72+ COLLINS CONDOMINIUM

7134 Collins Avenue
Miami Beach, Florida 33141

DESIGN REVIEW BOARD PRESENTATION

LEVEL 11 - BUILDING PLAN | 1

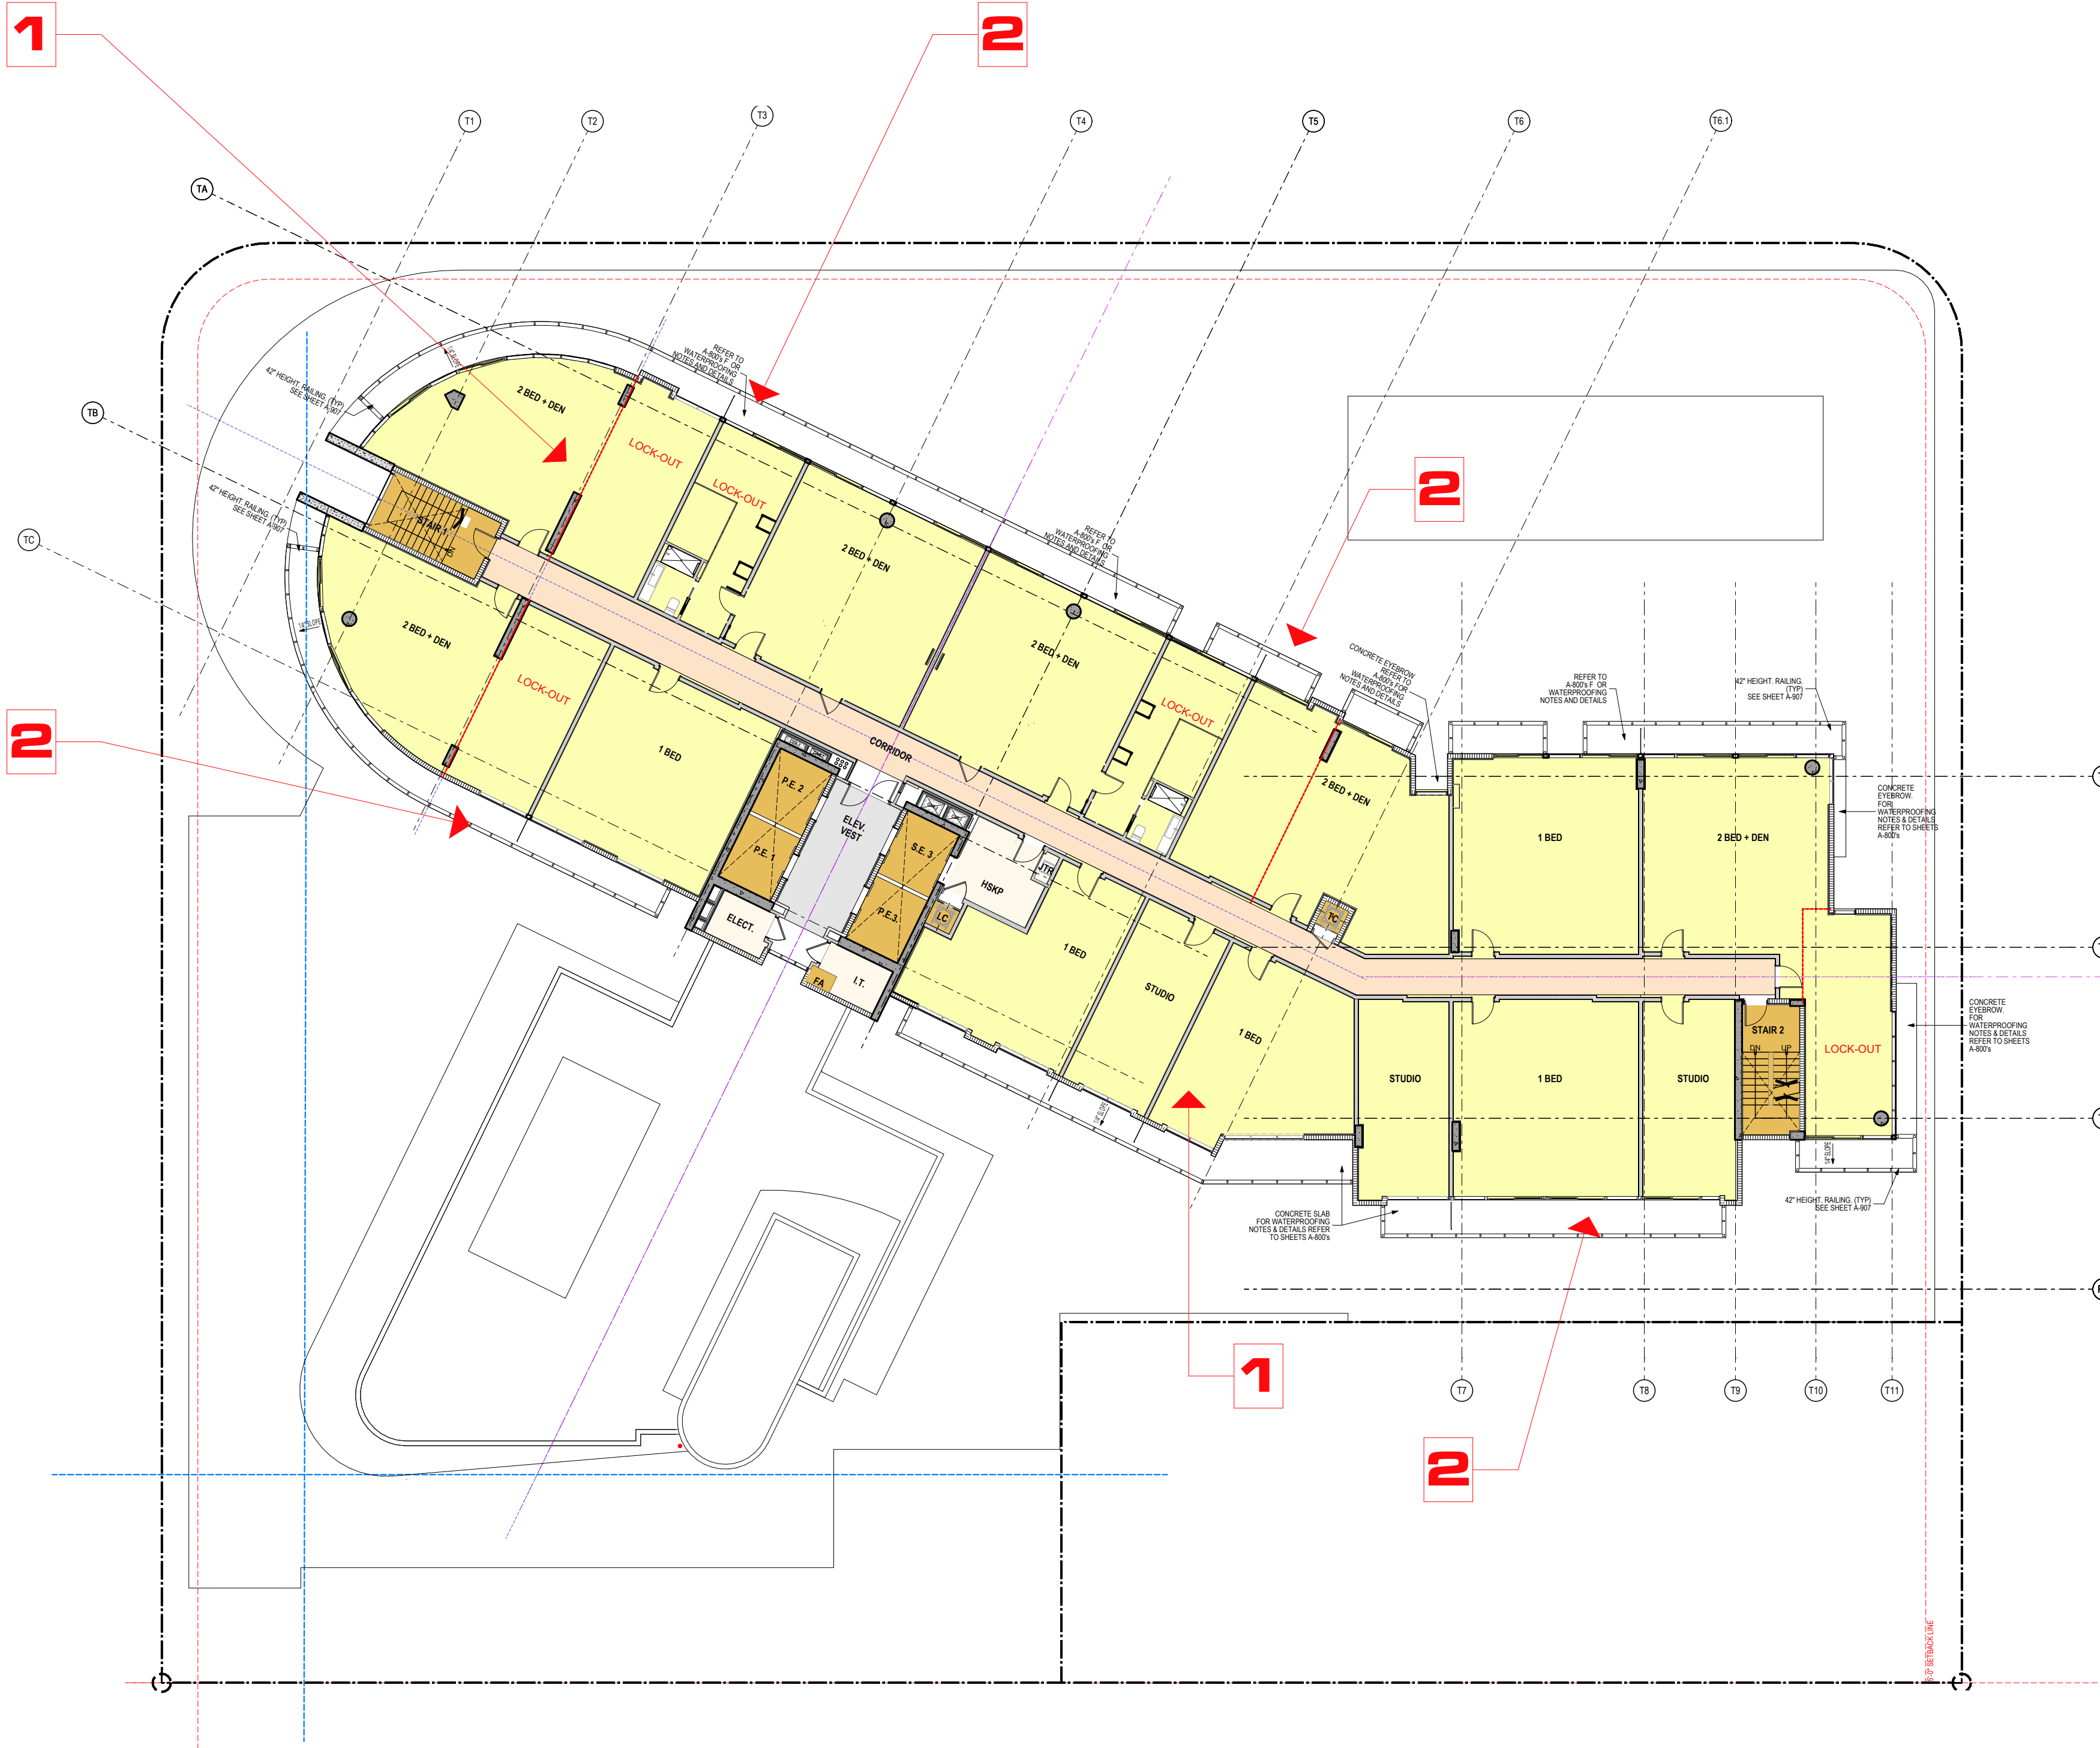
- INTERIOR ORGANIZATION TO ACCOMMODATE CO-LIVING UNITS AND NEW REGULAR UNITS
- REPLACING OF PREVIOUSLY APPROVED EYEBROWS BY BALCONIES AT NEW CO-LIVING AND REGULAR UNITS

ROOF LEVEL - BUILDING PLAN | 1

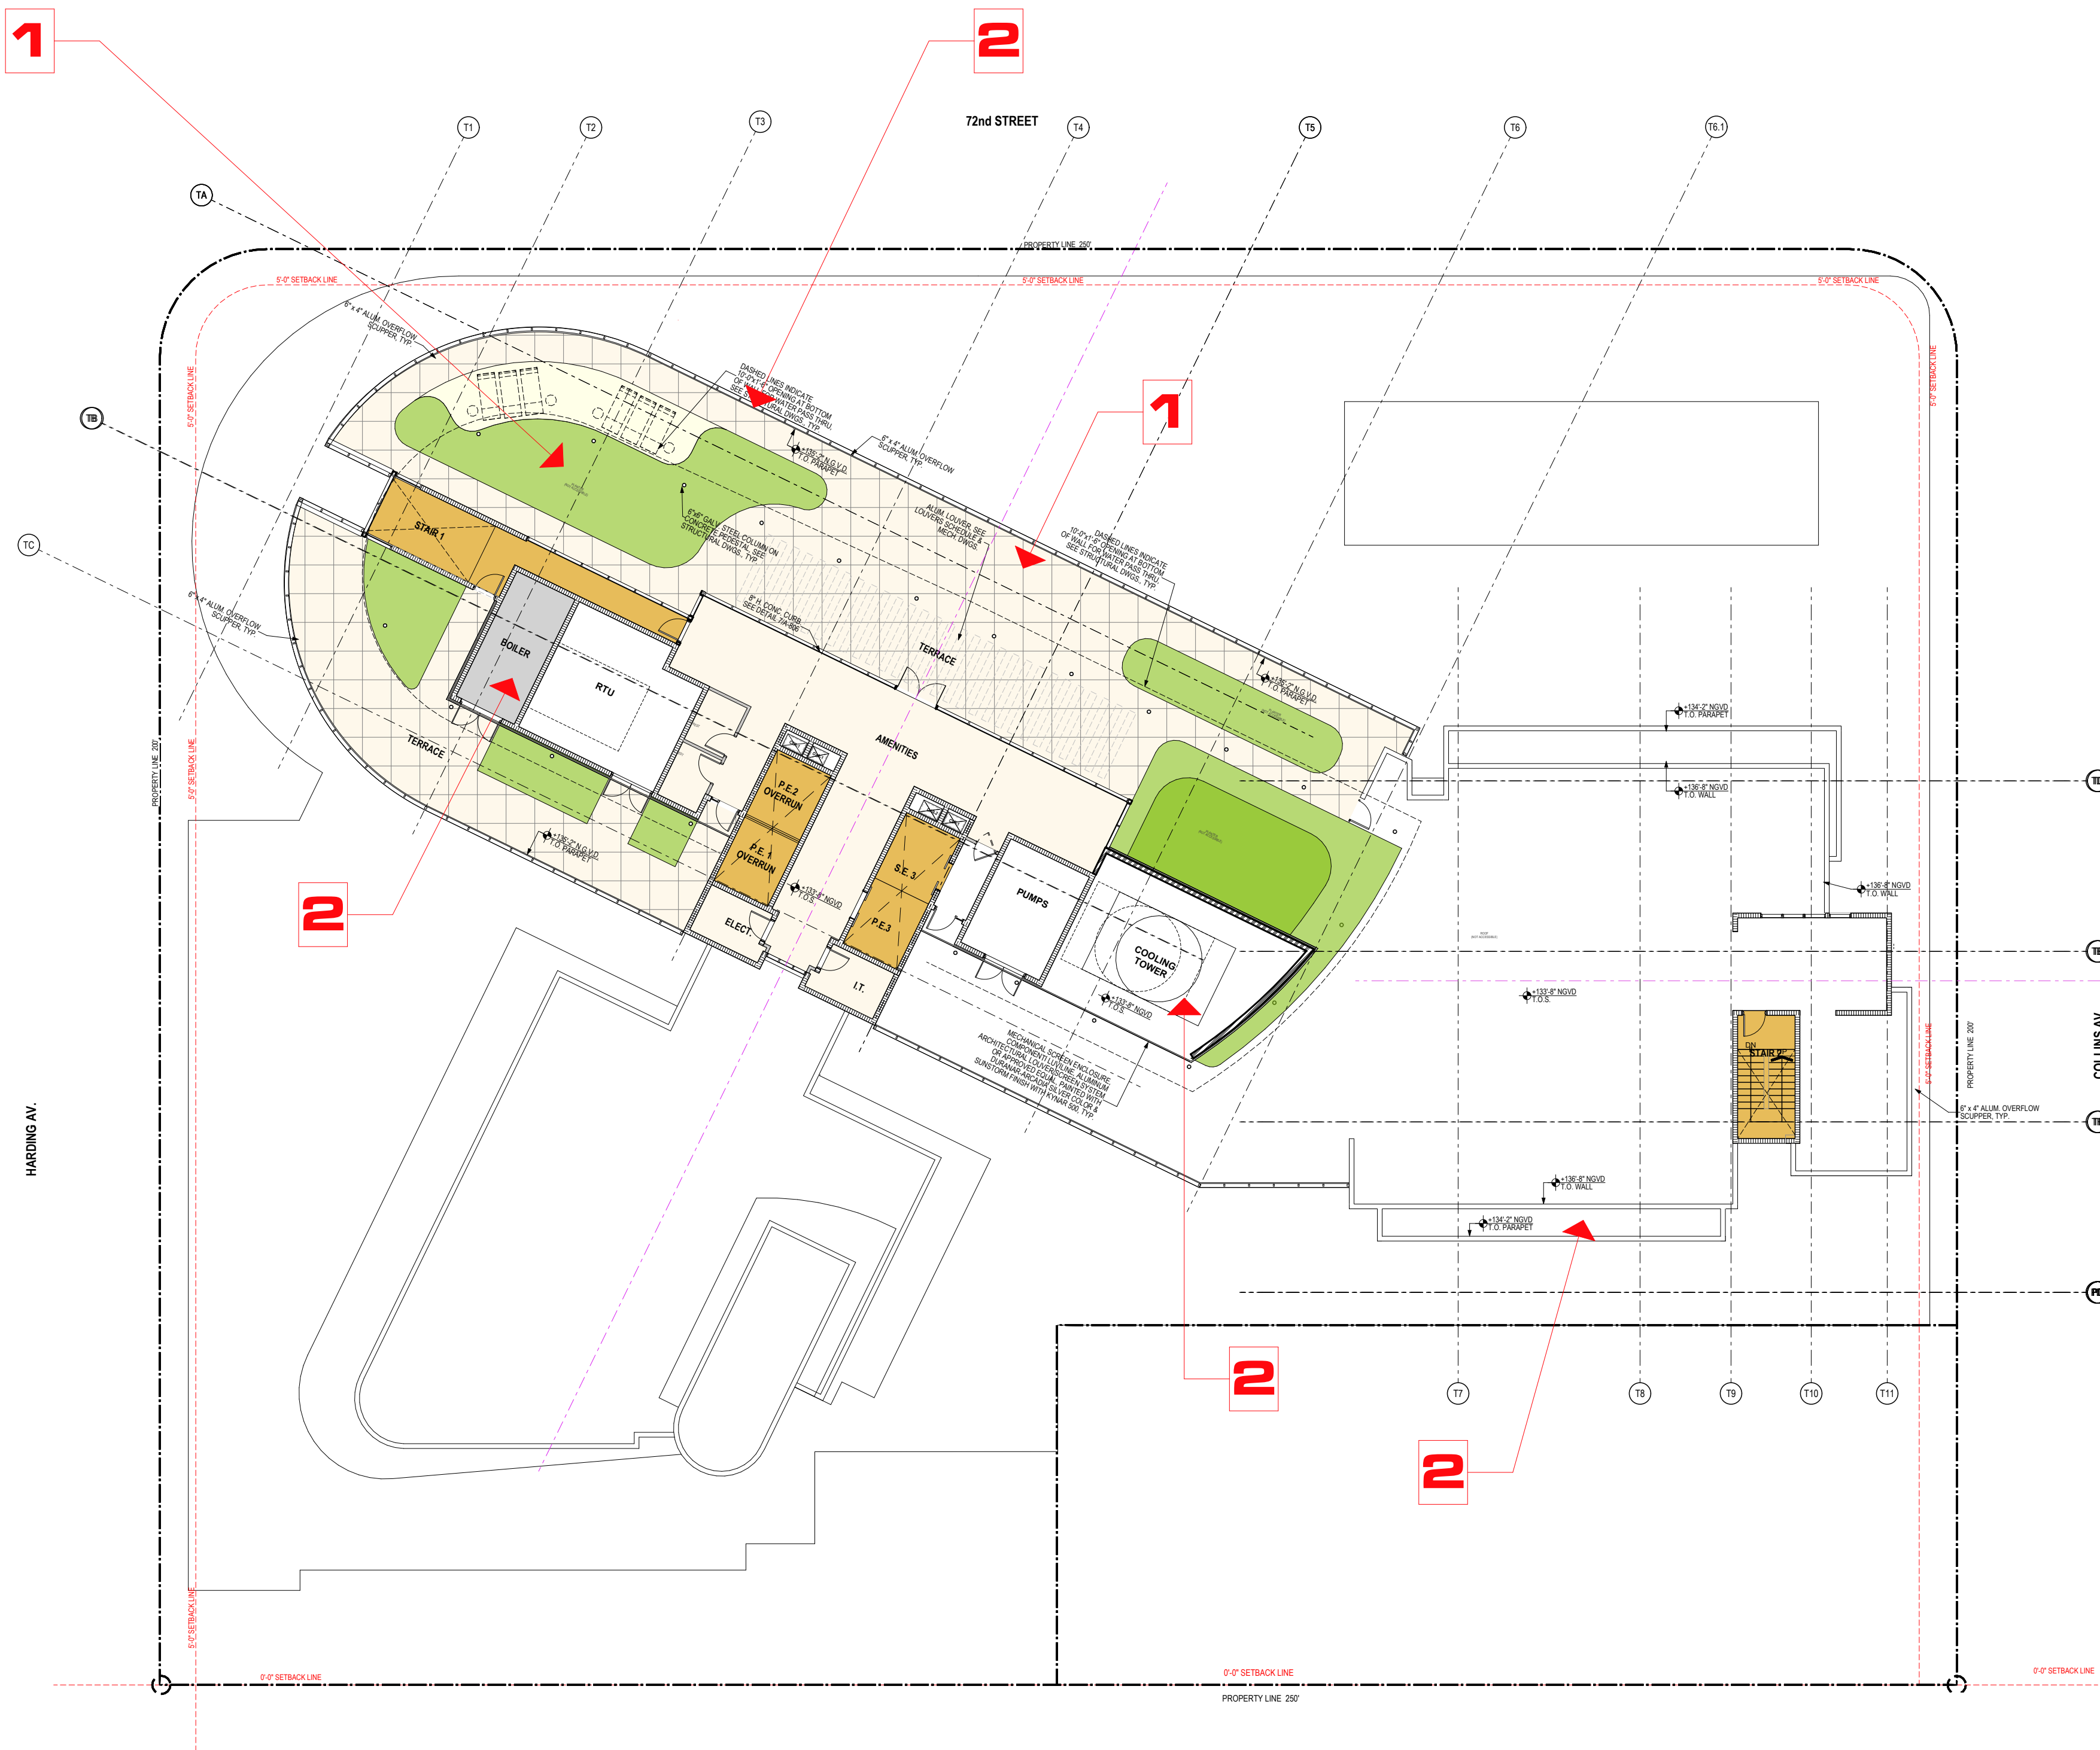
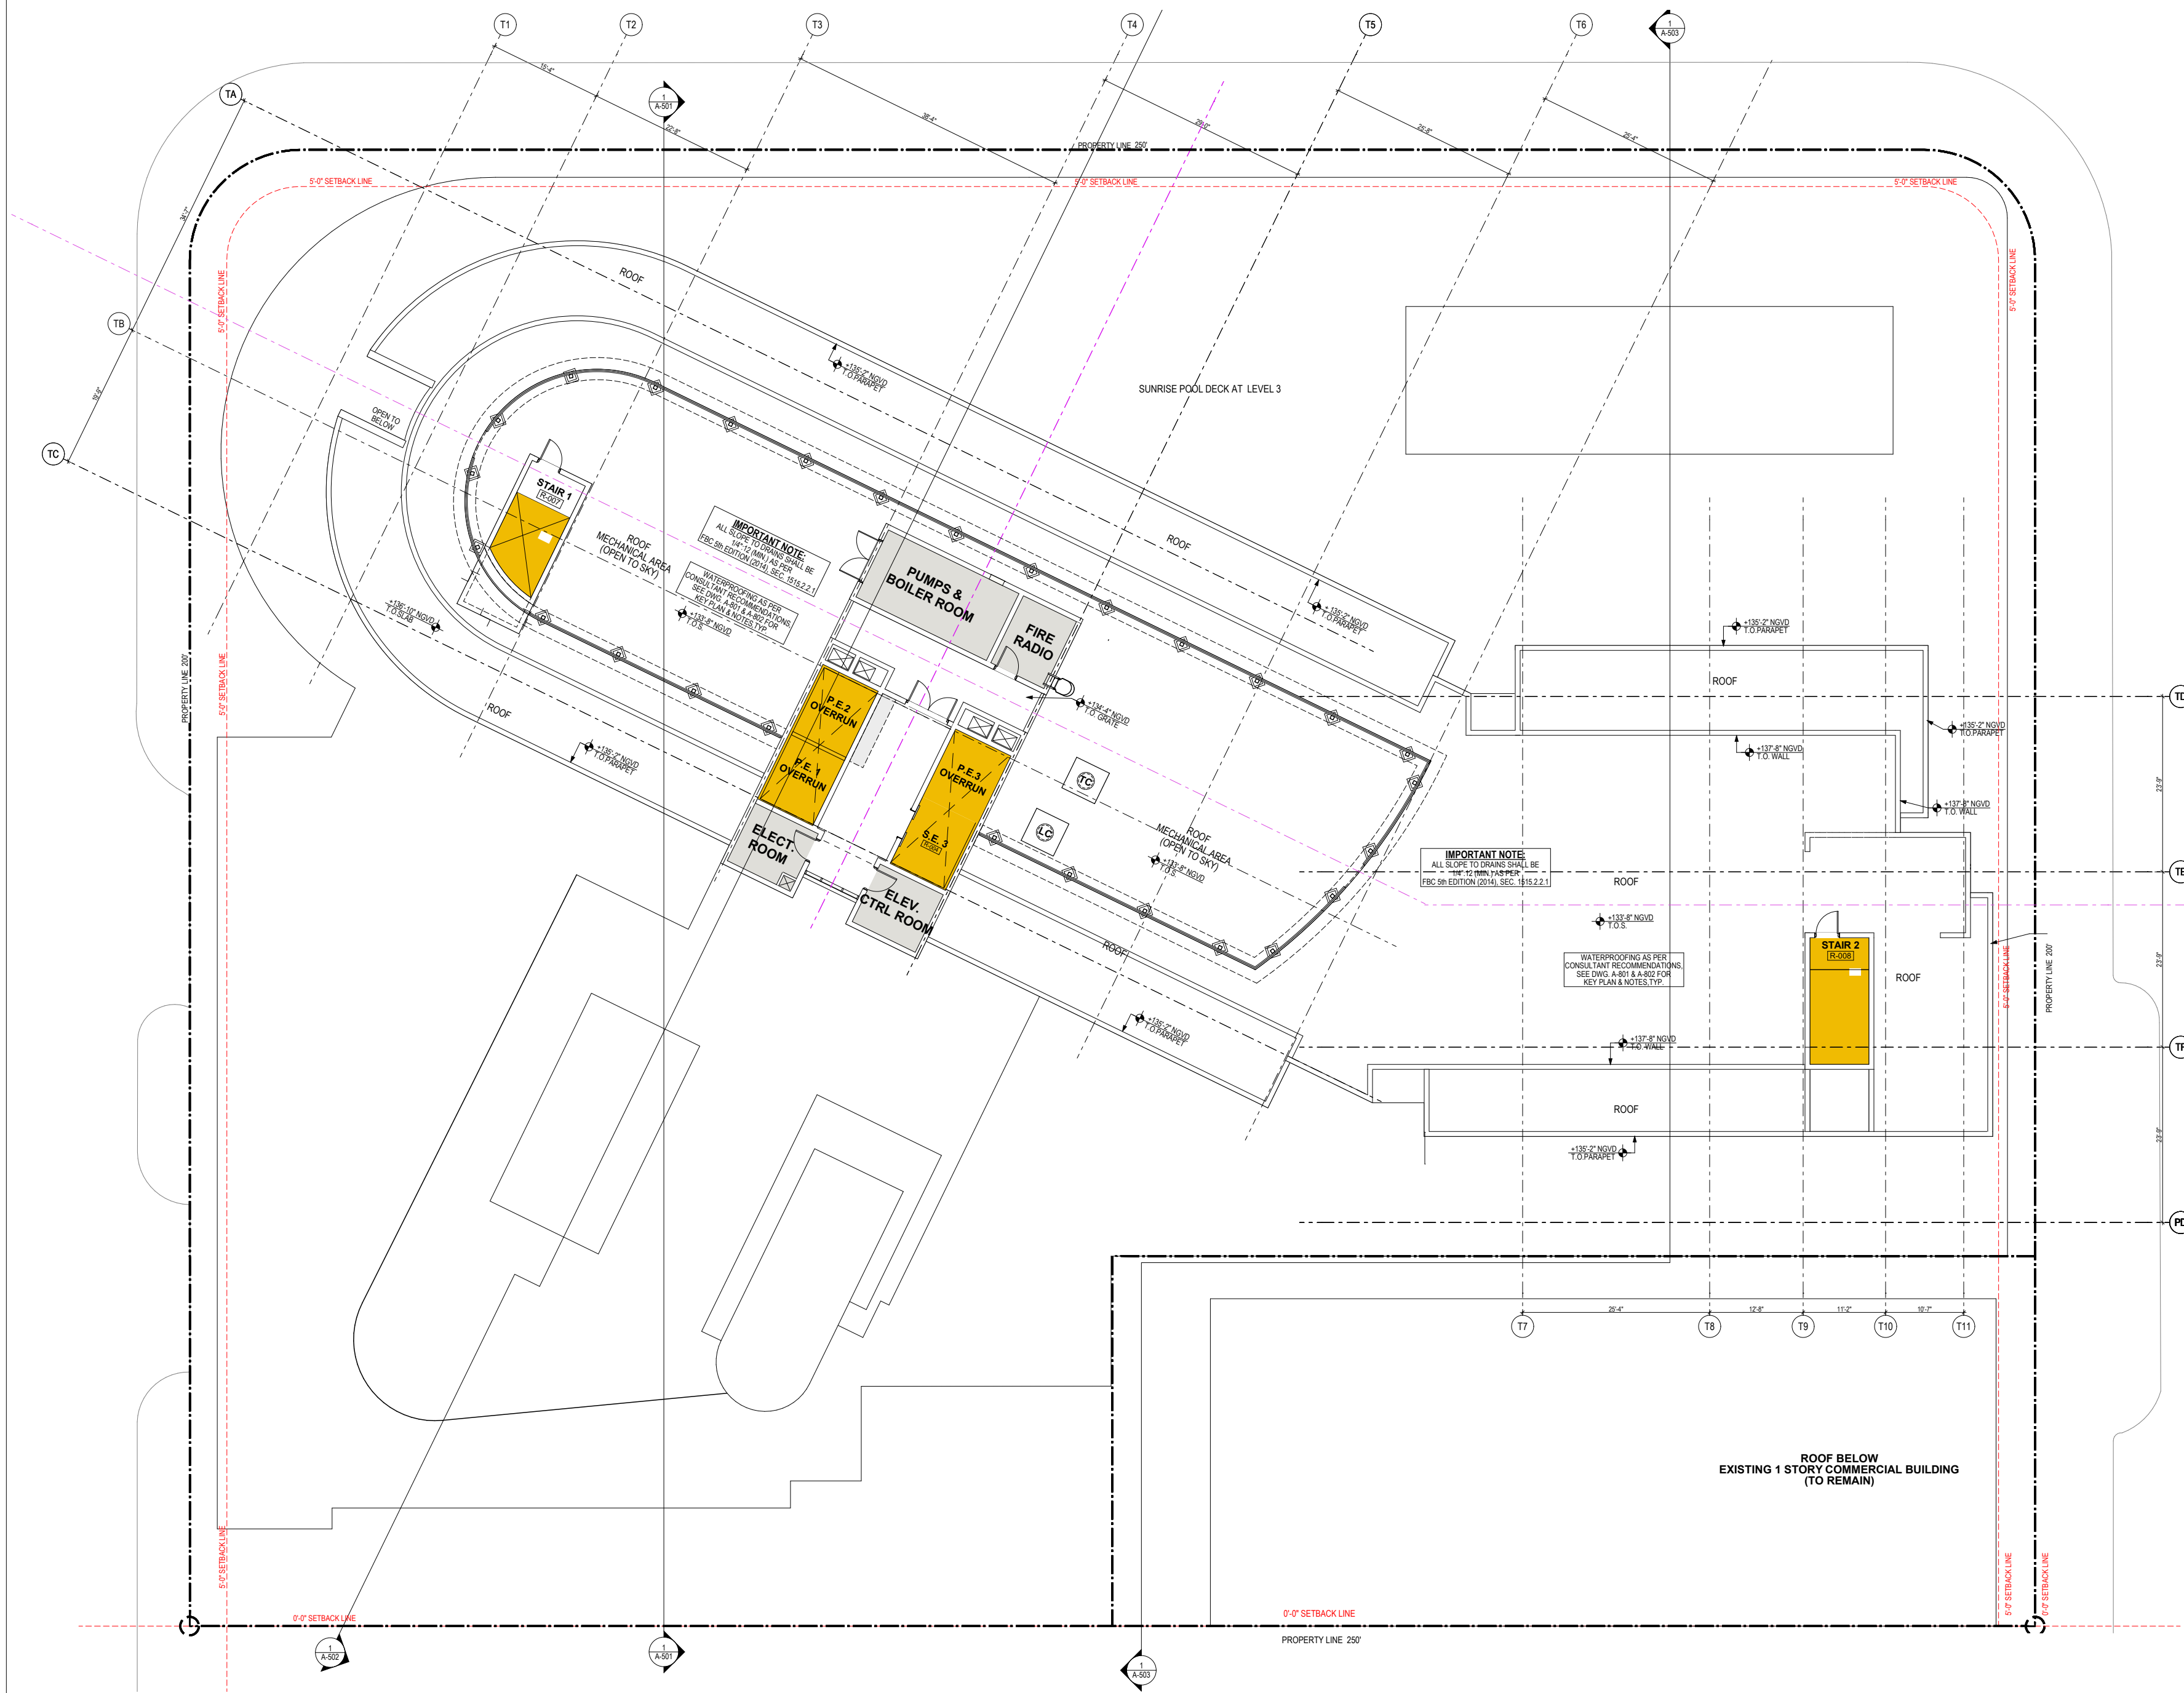
- PROPOSED NEW ROOF-TOP
- REORGANIZATION OF MECHANICAL AREAS
